# Expert Opinion on Drainage Issues

## Amendment C228 to the Casey Planning Scheme

Report Author:	Warwick Bishop
Report Prepared for:	The Minta Group
Instructed by:	Norton Rose Fulbright
Report Date:	6 April 2018

Figure 7-1 Engeny Stormwater Management Strategy Layout

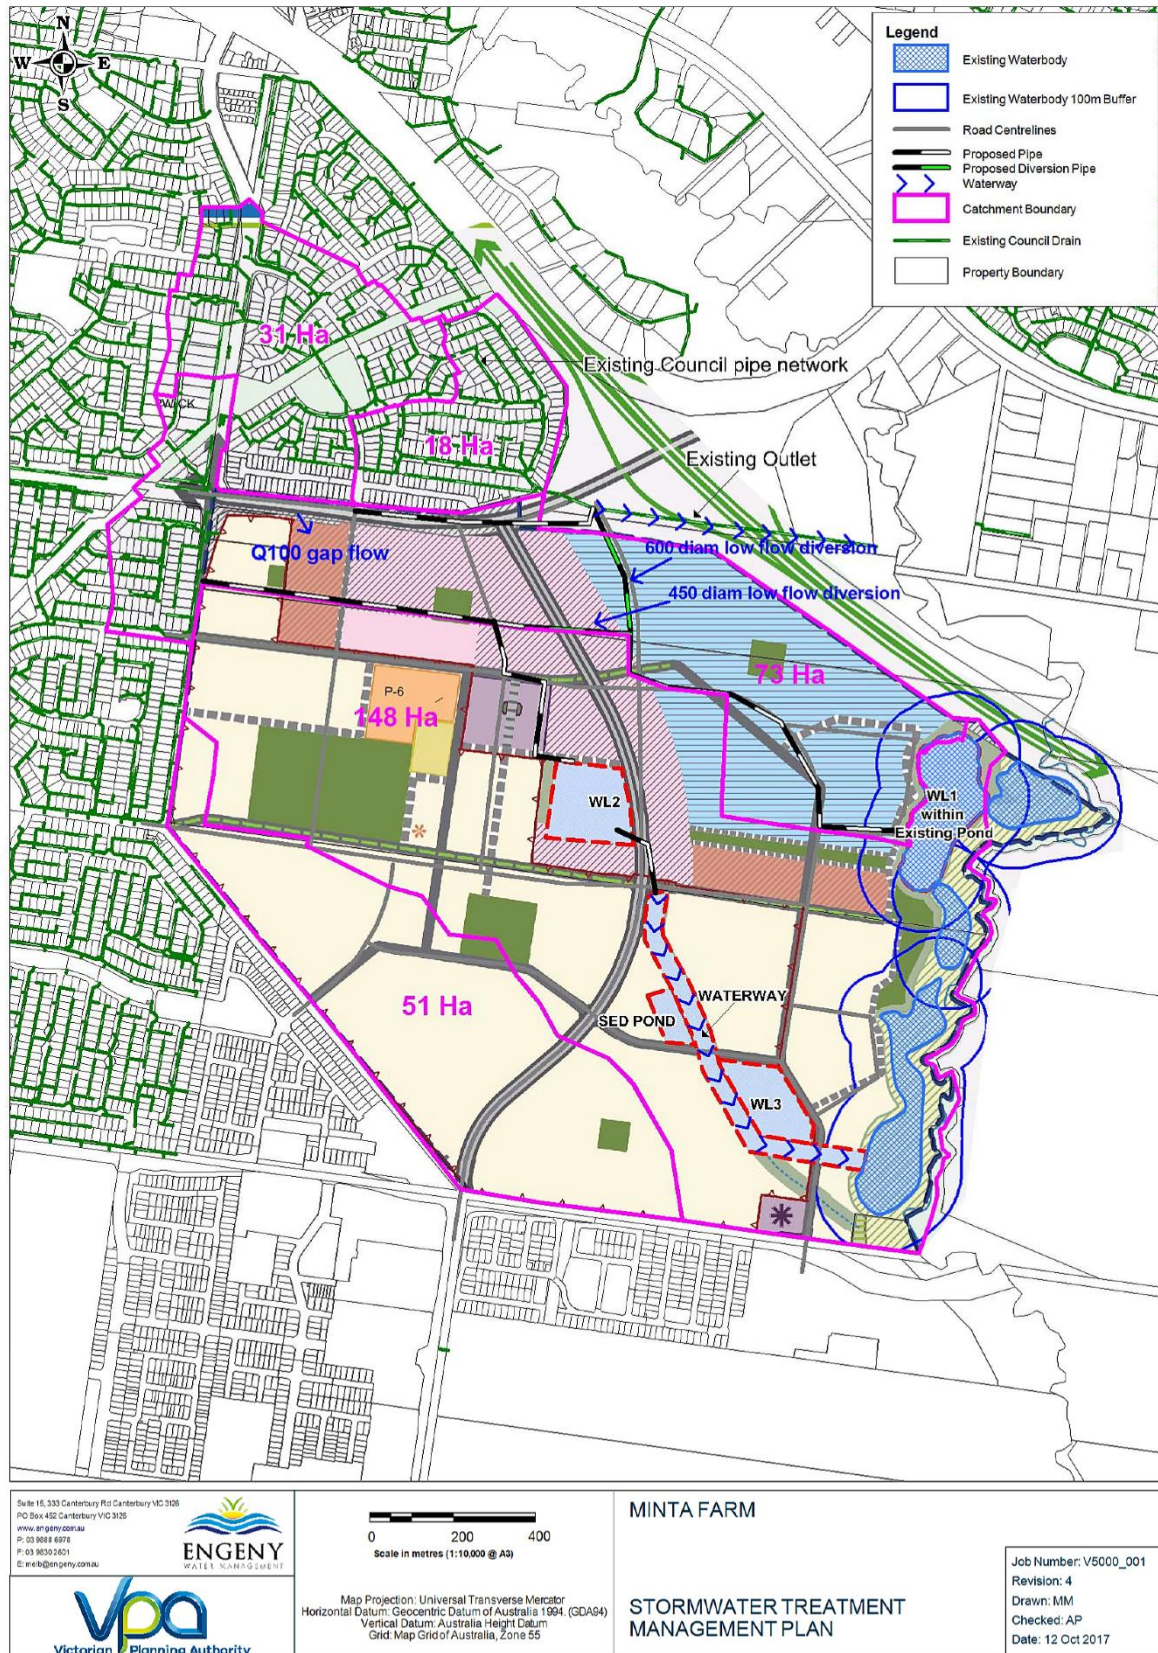
Issues in relation to the Engeny design are:

- The waterway flows diagonally through the southwest part of the subject site. This is not ideal from a residential development layout perspective, creating a barrier and some awkwardly shaped parcels of land.
- There may not be sufficient flow to sustain the northern-most wetland. In order to improve efficiency of Wetland 1 it is proposed to divert water from external catchments. However, this may have the result that the development will pay for a wetland to treat flows from outside the catchment while additional take land and construction costs will be borne by the

development to create additional internal wetlands to treat internal catchment flows. This is not in keeping with the principal of finding the most cost effective solution.

**Figure 7-2 Charlton Degg/Water Technology Stormwater Strategy Layout**

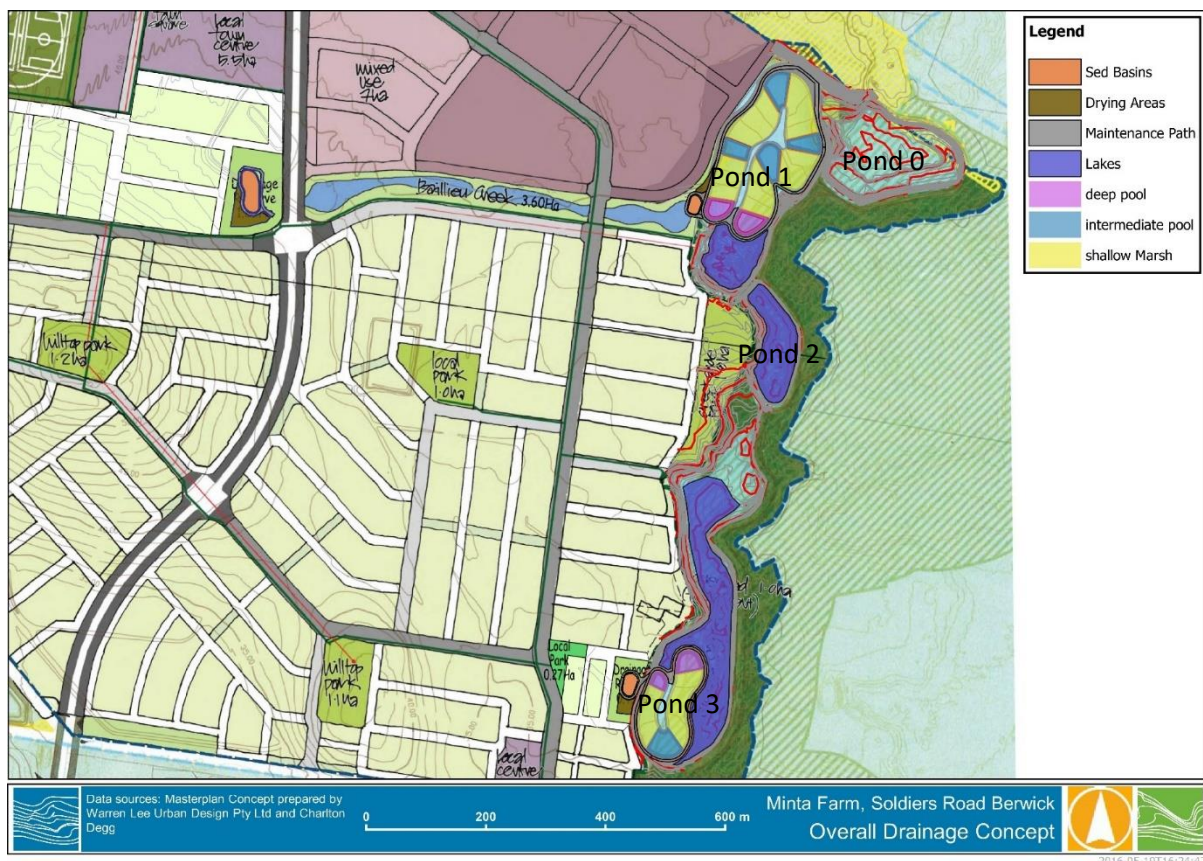
It is noted that no detailed assessment or review of the ecological values along the Cardinia Creek corridor, including the lakes, was undertaken as part of this report. However, the environmental overlay did inform the location and arrangement of potential constructed wetland sites. Care was taken to ensure water quality was maintained within the lakes system and lake turnover was optimised to reduce algal bloom risk, in response to feedback from Melbourne Water.

**Figure 7-3 Alluvium Water Management Scenario 1 Layout**

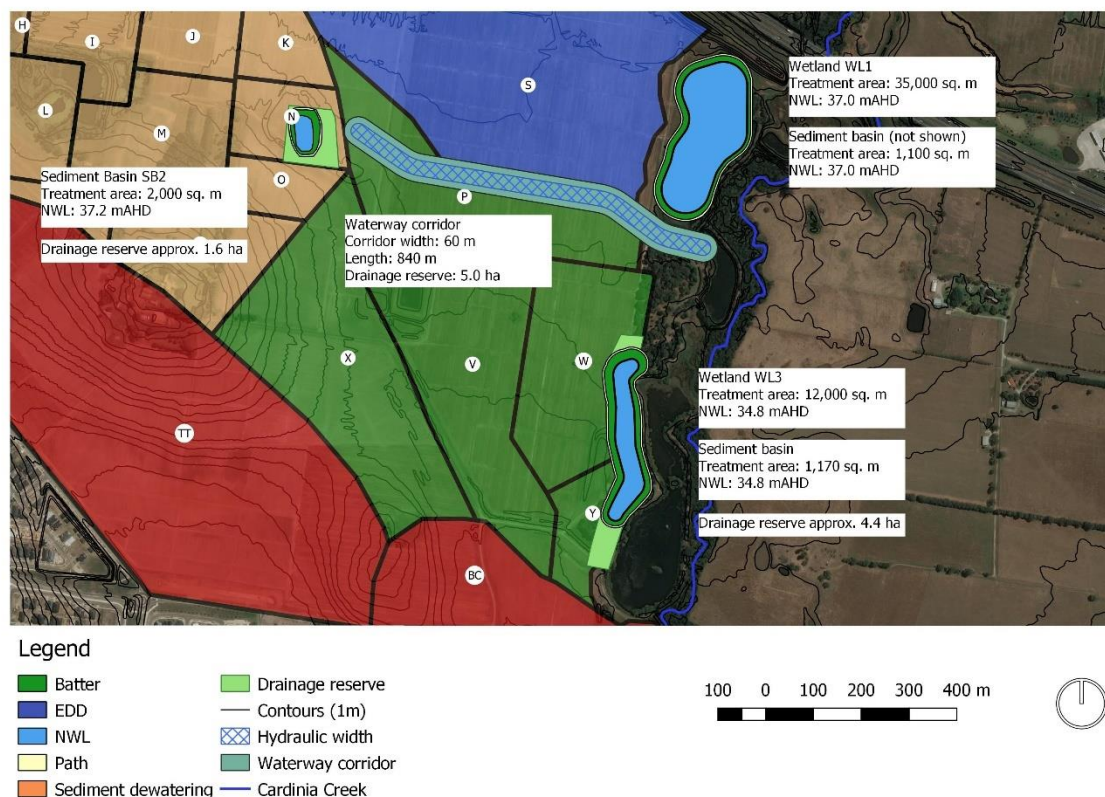
Scenario 1 is similar in concept to the Charlton Degg/Water Technology design with an east-west waterway corridor directing flow towards the lakes. There is a sediment basin proposed at the western end of the waterway corridor as in the CD/WT plan. The main difference is that Alluvium have located Wetland 3 outside of the current Pond 3 footprint, where the CD/WT plan had this wetland incorporated inside the pond footprint. This change is sensitive to the need to preserve the high-value pond 3 habitat and is a logical approach.

- Scenario 1 takes greater advantage of the existing pond assets, reducing land take and cost of constructing additional treatment wetlands.
- The east-west waterway corridor can provide an enhanced buffer between the residential development to the south and the commercial development to the north. This buffer already exists and could be enhanced with a constructed waterway with limited additional land required.

- Scenario 1 provides more flexibility in the management of the hydrologic regime of the sensitive water-dependent ecosystems along the Cardinia Creek corridor. This is because water can be either directed into the ponds or diverted to flow directly into Cardinia Creek. This will allow the appropriate sequences of wetting and drying the pond/wetland areas for improved ecological habitat. A large portion of the flow is also directed away from Pond 3 which has particularly high ecological value and would be potentially degraded by excessive inflows.

- Scenario 1 allows for a more flexible development layout, freeing the southern part of the site from the constraint of the waterway corridor.
- Siting Wetland 3 adjacent to Pond 3 complements the already significant habitat at that location that has been identified in the ecology reports.

**Figure 7-4 Alluvium Water Management Scenario 2 Layout**

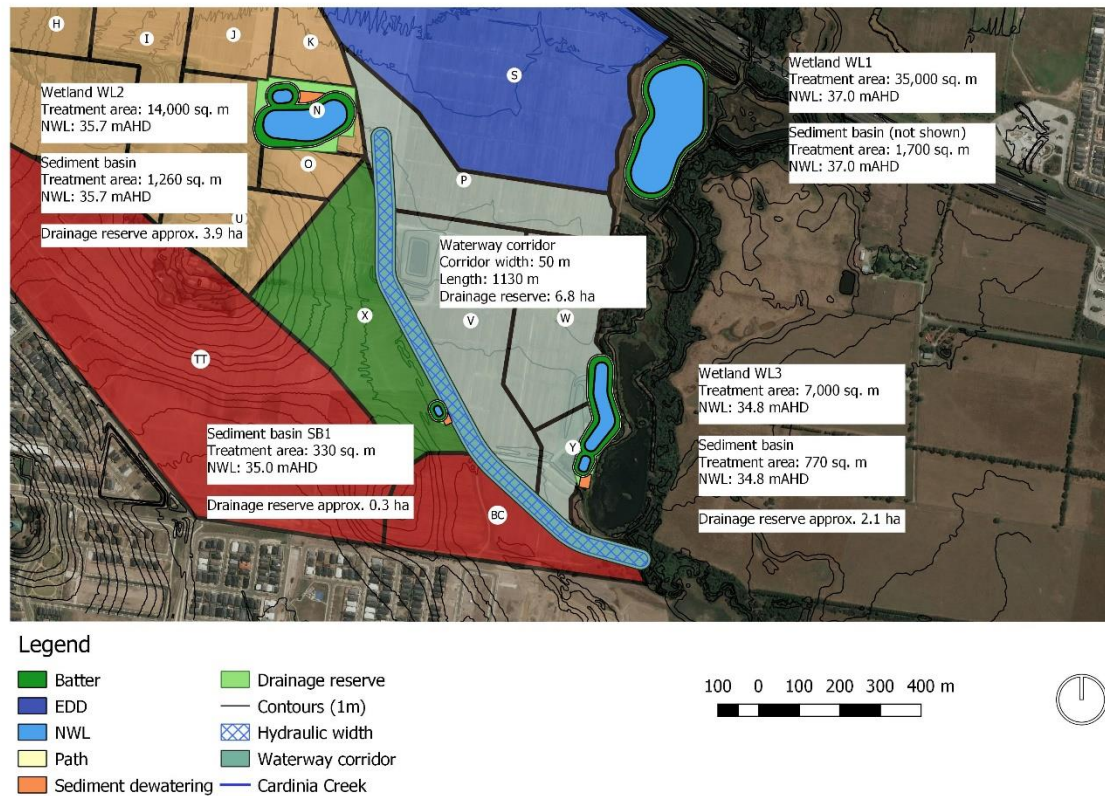
Scenarios 2a and 2b are considered to be similar to the Engeny design, with a constructed waterway flowing towards the south-west carrying the majority of runoff from the site. The main difference compared to the Engeny design is the location and configuration of Wetland 3, which is aligned next to pond 3, rather than alongside the constructed waterway.
